UNITED STATES PATENT AND TRADEMARK OFFICE

APPLICATION NO.	FILING DATE	FIRST NAMED INVENTOR	ATTORNEY DOCKET NO.	CONFIRMATION NO.
10/587,469	03/26/2007	Rodney James Dry	T2211-11786US01	5189

Office Action Summary	Application No. 10/587,469	Applicant(s) DRY ET AL.	
	Examiner TIMA M. MCGUTHRY-BANKS	Art Unit 1793

DETAILED ACTION

Fig. 1

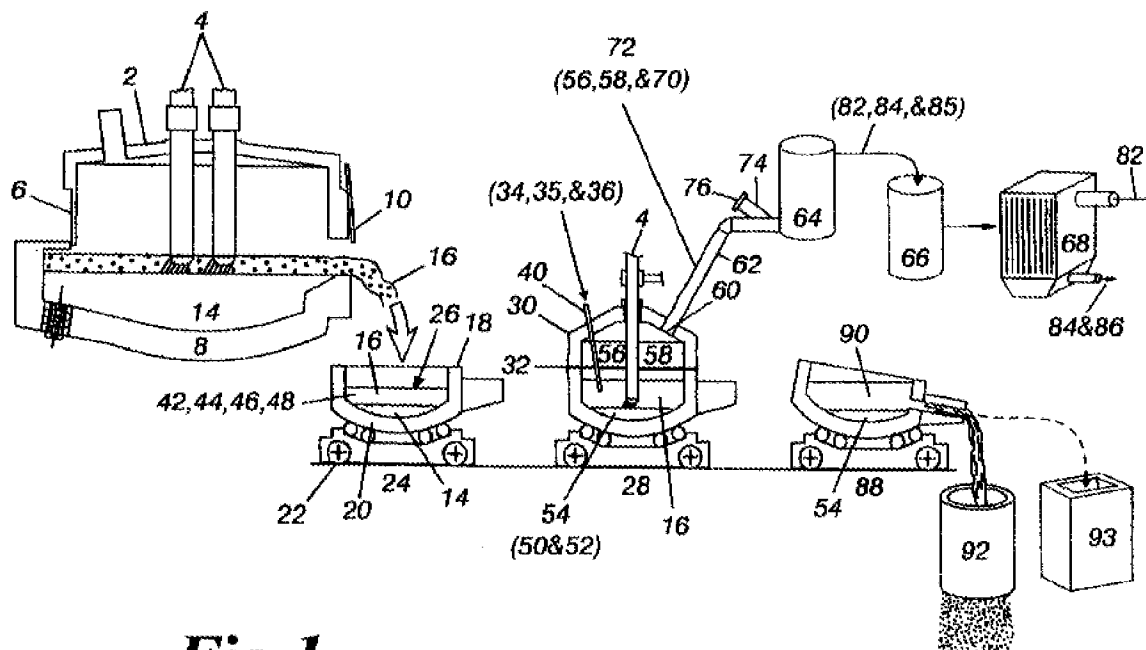
Vallomy teaches a method for recovering metal values from liquid slag from a steelmaking furnace as shown below in Fig. 1:

Steelmaking slag 16 from the EAF 6 is added to molten metal 14 in vessel 18. The molten metal contains iron (column 2, line 63). SiO_2 is introduced into the molten slag (line 42). Carbon, baghouse dust and inert gas are inserted in the vessel via a lance (column 5, lines 42-44). Metallic oxides are reduced (column 5, line 30). Regarding the limitation that the slag forming agent directly as opposed to pre-treating, it would have been obvious to one of ordinary skill in the art at the time the invention was made that the heated SiO_2 added to the vessel reads on the claimed invention, since applicant does not claim what the pre-treating steps entail. However,
